**RESPONSE TO GROUNDWATER-RELATED COMMENTS
PROVIDED IN EPA'S NOVEMBER 1, 2007 LETTER**

General: The United States Environmental Protection Agency's (EPA's) November 1, 2007 letter regarding groundwater-related issues contained comments on the Intermediate (60%) Design Reports (Intermediate Design Reports) for the low-temperature thermal desorption (LTTD) and off-site disposal (OSD) soil remedies for the Fletcher's Paint Works and Storage Facility Superfund Site in Milford, New Hampshire. However, the substance upon which EPA commented in its November 1, 2007 letter was not presented in the Intermediate Design Reports for the Site. It was presented in the Environmental Monitoring Plan (EMP) and the Institutional Controls/Access Restrictions Plan (IC/AR Plan) that the General Electric Company (GE) was in the process of preparing when the Intermediate Design Reports were submitted to EPA on June 4 and 12, 2007. The EMP and IC/AR Plan were subsequently submitted to EPA on July 30, 2007, along with a revised Surface Water and Groundwater Monitoring Plan (also known as the Water Monitoring Plan [WMP]). The EMP provides specific details regarding the scope of the post-construction ground

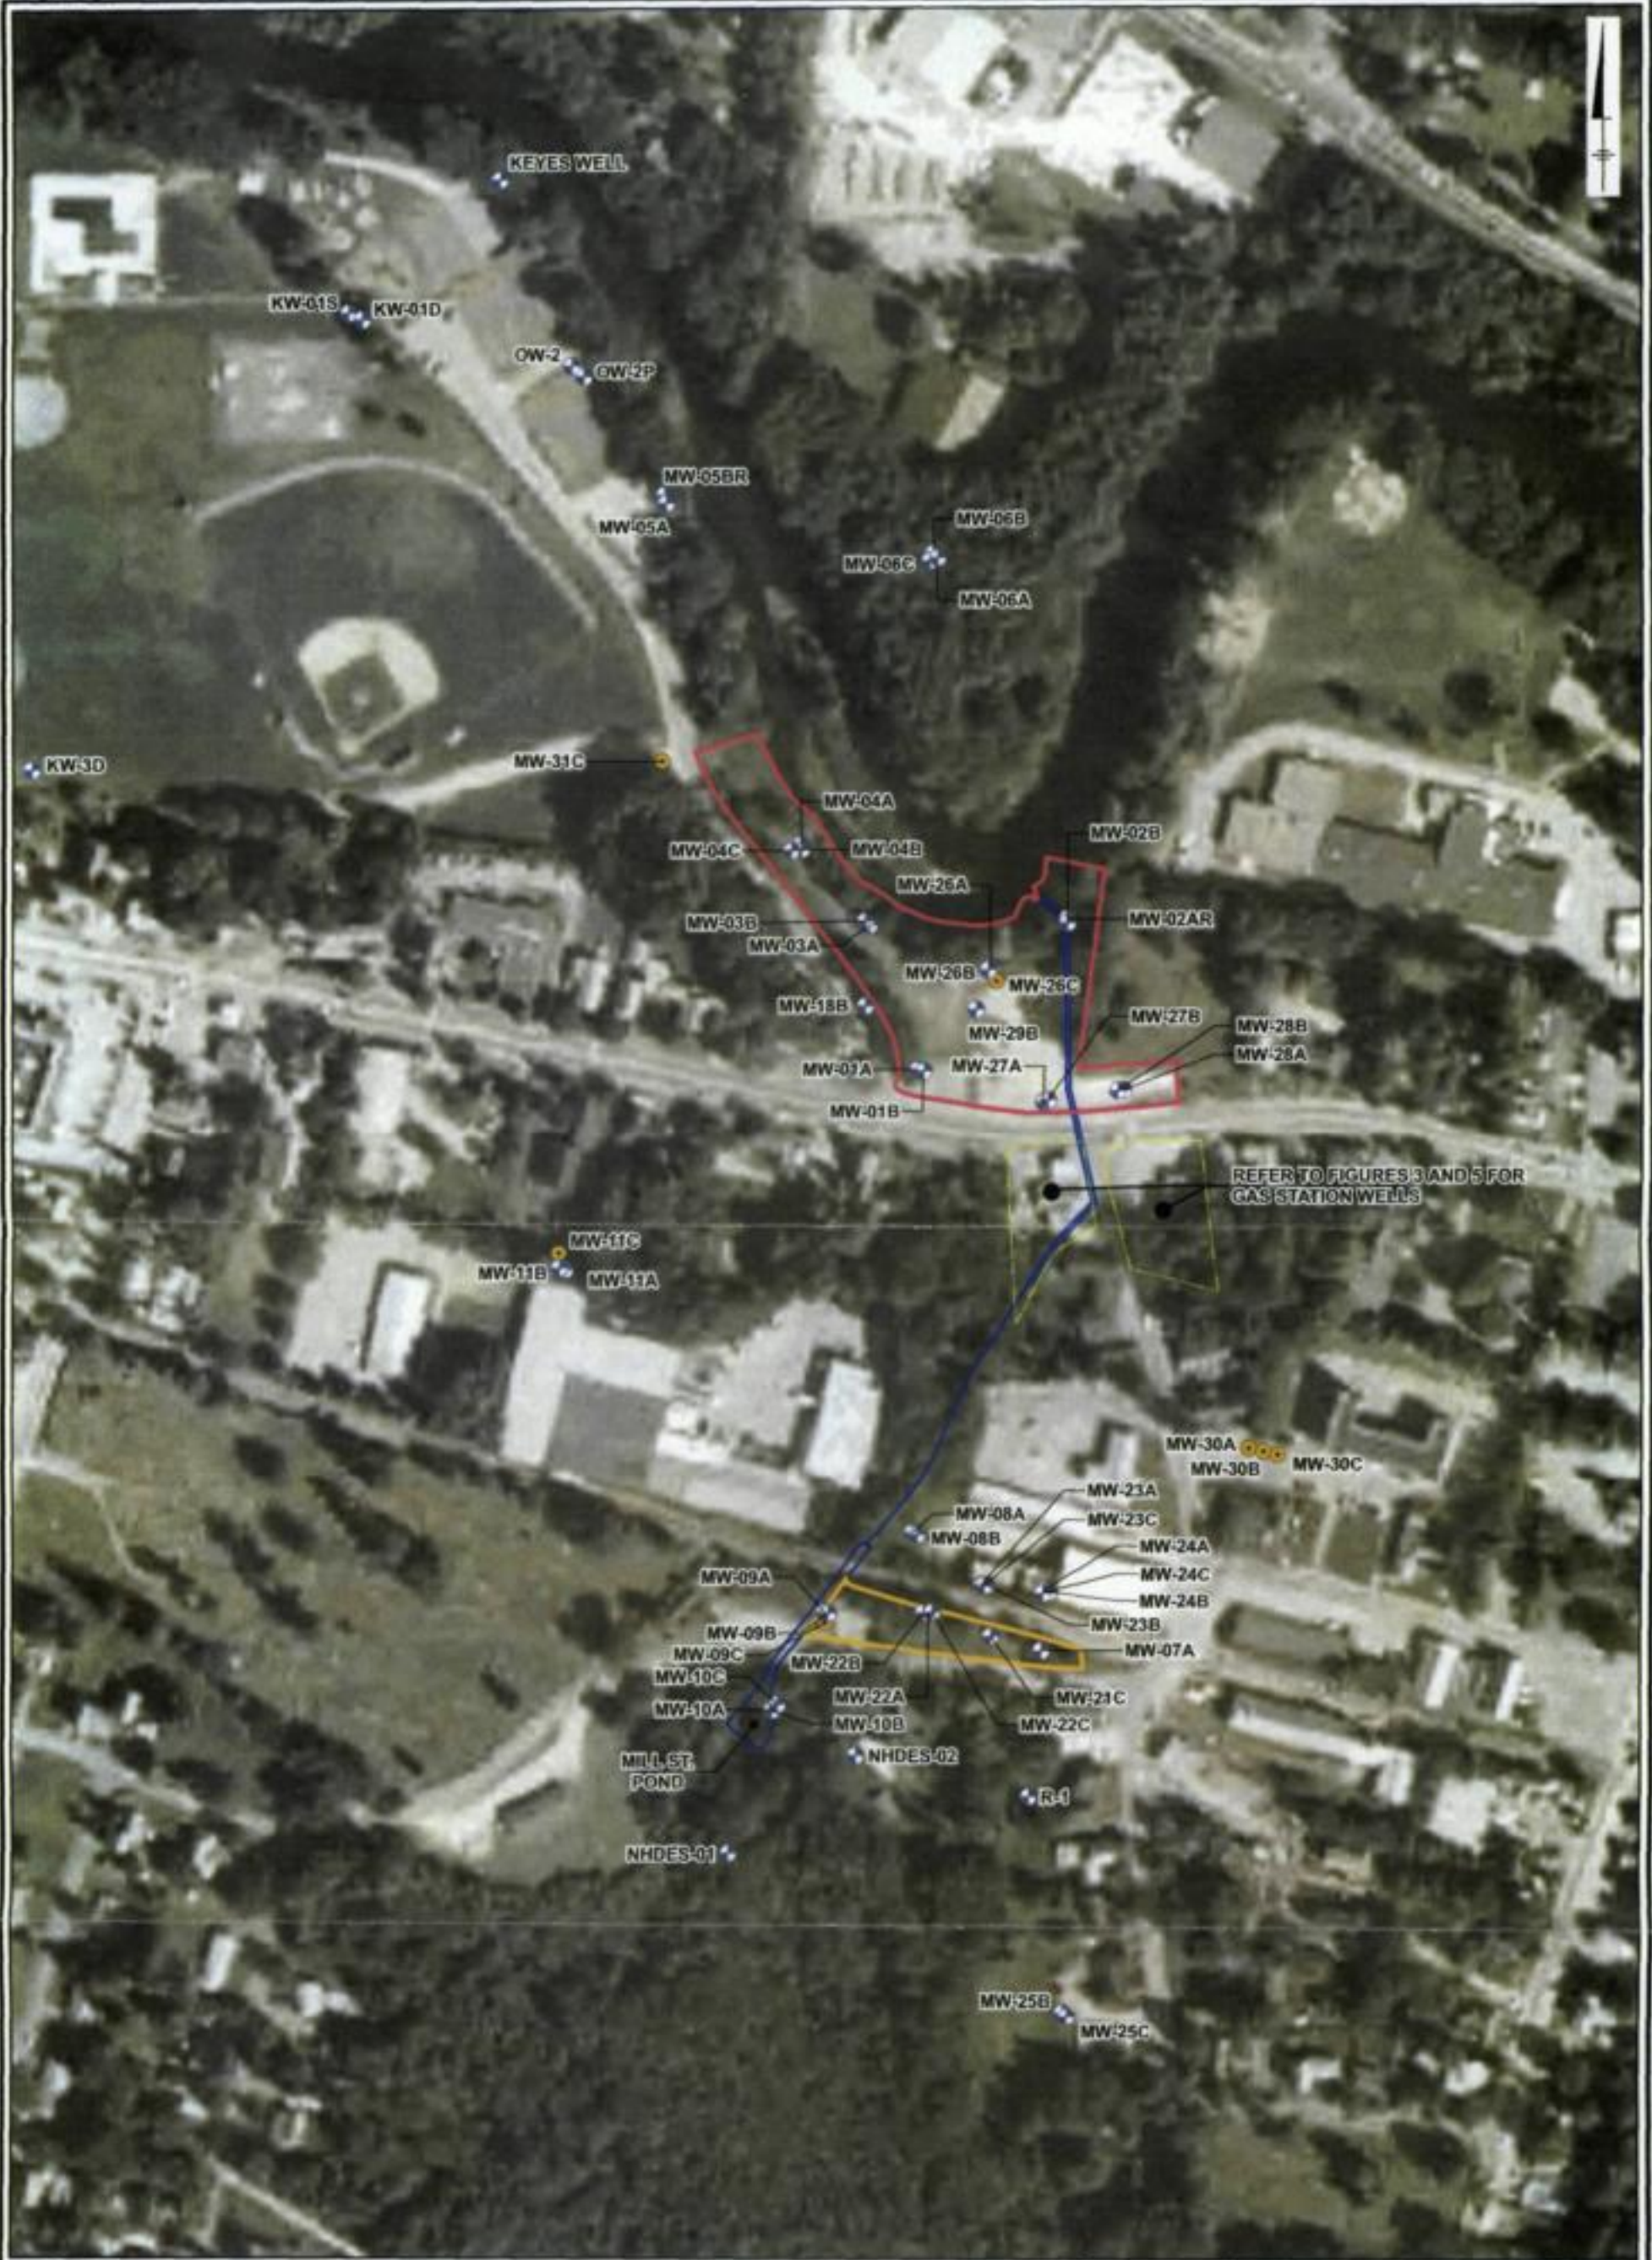
EPA Comment 1: *GE's proposed boundary for the GMZ is much larger and more inclusive of large parcels of land than is warranted for establishment of the GMZ. Where EPA determined a lack of adequate data existed to establish or define a boundary, GE included entire parcels of property, rather than proposing the installation and monitoring of groundwater to establish boundary conditions. GE's response to comments indicate that rather than obtain the necessary data to justify the boundary conditions, GE sought to expand the boundary to include enough property to account for potential contamination transport and attenuation. GE's method never truly establishes boundary conditions using data that would demonstrate that contamination is not migrating to or beyond the boundaries of the GMZ.*

EPA noted that there is no available bedrock data in the vicinity of MW 9. GE expanded the boundary of the GMZ out 180 feet, rather than propose the installation of a bedrock well at this location to monitor bedrock contamination in the direction of migration. EPA and NHDES believe a bedrock well in this location is justified as GE's October 15, 2007 Monitoring Report indicates that the groundwater flowpath in bedrock is, in part, moving across Mill Street in the direction of MW9. Groundwater contamination from MW-21 C, the most contaminated well at the site, where DNAPL has been found is the closest bedrock well upgradient of the MW-09 location.

In a similar instance, GE uses an expanded GMZ to include numerous acres of both the Keyes Field (25-133) and the Mill Pond property (25-95). The intent of the GMZ under NH's Groundwater Management Policy is not to include such a large area within the GMZ as to render monitoring of the boundaries useless, but to be able to define and monitor the groundwater contamination such that groundwater contamination does not migrate beyond the boundaries. Expanding the GMZ to include large parcels also unfairly burdens the property owner, especially if groundwater contamination is not throughout the entire property. The groundwater data and groundwater flow paths do not justify including these two large parcels within the GMZ and further the installation of additional wells would establish "clean" boundary conditions to be monitored in the future. Groundwater data from the Keyes Field was collected in 2007 and provided to GE. This data indicates no exceedances of ICLs in groundwater in the Keyes Field monitoring wells. A monitoring well series located in the groundwater flowpath along the eastern edge of Keyes Field would allow the GMZ to include only the eastern-most portion of the Keyes Field.

EPA Comment 7: *The GMZ boundary is proposed as the southern edge of river on the basis that data collected during the RI in the early 1990's met water quality criteria. According to the data at the site, groundwater contamination appears to have migrated toward and discharges into the Souhegan River. Groundwater contamination near the river exceeds ICLs. Bedrock contamination may be migrating between the sites to the river, especially in light of DNAPL contamination found in the bedrock which may provide a long-term source of contamination. In addition, property lines along a river typically extend to the center of the river and therefore GMZ boundaries typically extend to the center of a river.*

Notwithstanding the above, GE proposes to install a bedrock monitoring well at cluster MW-09 when the OU-1 soil remedy is completed. This well, designated MW-09C, would be installed at the same time that overburden wells MW-09A and MW-09B are replaced. GE also proposes to install a new shallow bedrock monitoring well, designated MW-31C, in Keyes Field. GE proposes to install this well concurrent with the installation of monitoring wells MW-09C and MW-26C. The locations of these two new bedrock wells are illustrated on revised Figures 6 and 7 of the EMP, WMP, and IC/AR Plan, all of which are attached hereto.

Response: As directed by EPA, the northern boundary of the GMZ presented in the IC/AR Plan has been modified to be the midline of the Souhegan River in the vicinity of the Elm Street Area and Keyes Field. Accordingly, Figure 7 of the IC/AR Plan submitted on July 30, 2007 has been revised and is attached. Figure 7 of the WMP and Figure 7 of the EMP have also been revised and are attached; these two documents were also submitted on July 30, 2007. Despite this revision to the GMZ boundary, the surface water and sediment in the Souhegan River are part of Operable Unit 2 (OU-2).

GE has not seen a map of the GMZ associated with the Milford Xtra Mart gasoline station that extends out into the Souhegan River. However, per the Groundwater Management Permit (GMP) issued by NHDES for that site, the GMZ does include parcel 25-133 (i.e., Keyes Field). Based on EPA's comment, Figure 6 of the IC/AR Plan submitted on July 30, 2007 has been revised to show the GMZ for the Milford Xtra Mart gasoline station extending outward to the midline of the river. This revised figure is attached.
